Planning Commission Staff Report

CRANDALL COVE MINOR SUBDIVISION

Preliminary Plat

PLNPCM2010-00182

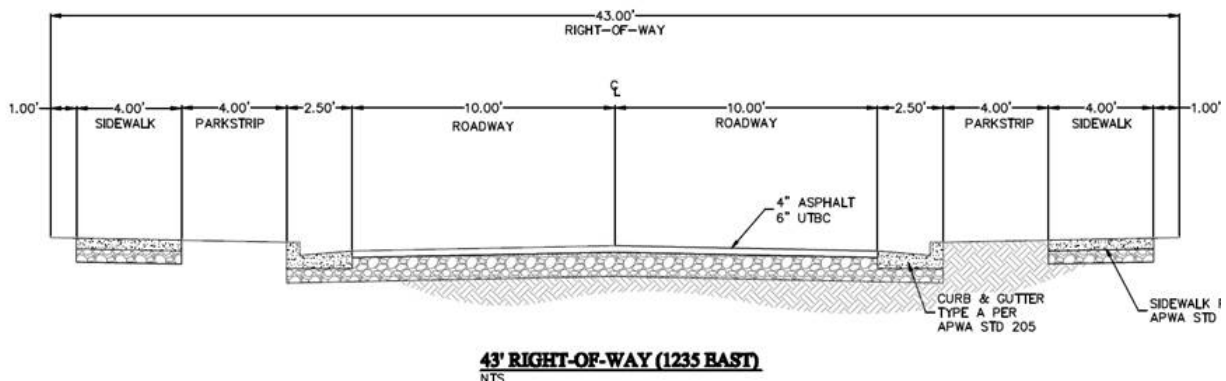
Brad wanted to know what we used to allow, back when the Planning dept was trying to promote residential infill on awkward lots. The 24' face of curb to face of curb or 20' from lip to lip was our minimum road width and was restricted to "NO" parking on street. I mentioned that it caused congestion and that I would require that the garages be set back a minimum of 20 feet from the back of walk to provide some visitor parking in that area. We also needed the pedestrian sidewalk and the one foot area for signing (No Parking) etc. I again noted that the turnaround at the end of the street is of concern to garbage pick-up and snow removal even if the road was less than 150 foot deep for fire codes.

So the proposed section is not per our current standard for various reasons and it would be up to Planning to approve in conjunction with the other departments for their conditions.

We require the NO parking status and on site provisions for guest staging.

After discussions with the Brad Mackay of Ivory Homes, I can't tell where Transportation stands on ROW requirements for Crandall Cove. I assume you are sticking with the standard 50' ROW / 30' curb to curb unless the planning commission approves otherwise. However, Brad Mackay mentioned you are okay with a 43' ROW / 24' curb to curb / 1/2' curb sections / 4' parking strips / 4' sidewalks / 1' signage (see image below). The Site Dev Ordinance says the standards contained therein shall apply unless deemed unwarranted by written recommendation of City Engineer and Traffic Engineer.

There has been much email, verbal, and phone conversation on this project but I do not recall if the "written recommendation" was provided clearly stating that the 50'/30' standard is unwarranted and that the 43 ROW scenario shown on the image is acceptable to Transportation. Are you willing to provide that to clear up any confusion?
